Proposed Revisions to a Standard Plans Index

Index Number: 455-154 Sheet Number (s): 1 of 3

Index Title: 54" PRECAST/POST-TENSIONED CFRP & SS

CONCRETE CYLINDER PILE

455-154

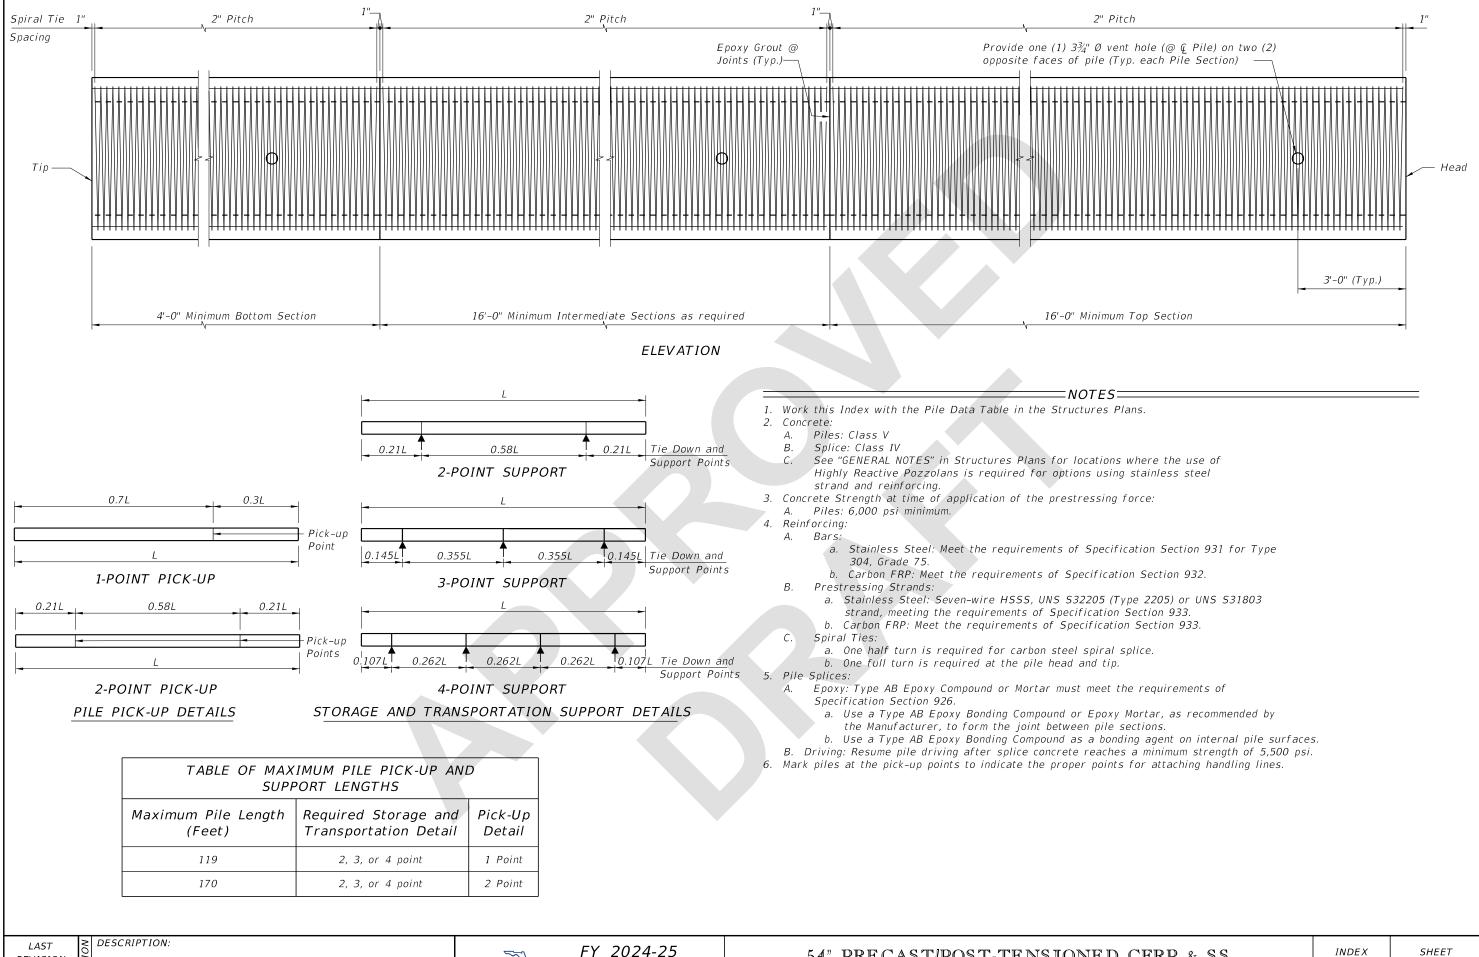
Sheet 1: Corrected note 3 language for clarity.

Sheet 1: We needed to correct the terminology so that it was clear that the value provided correlated to the application of prestressing force.
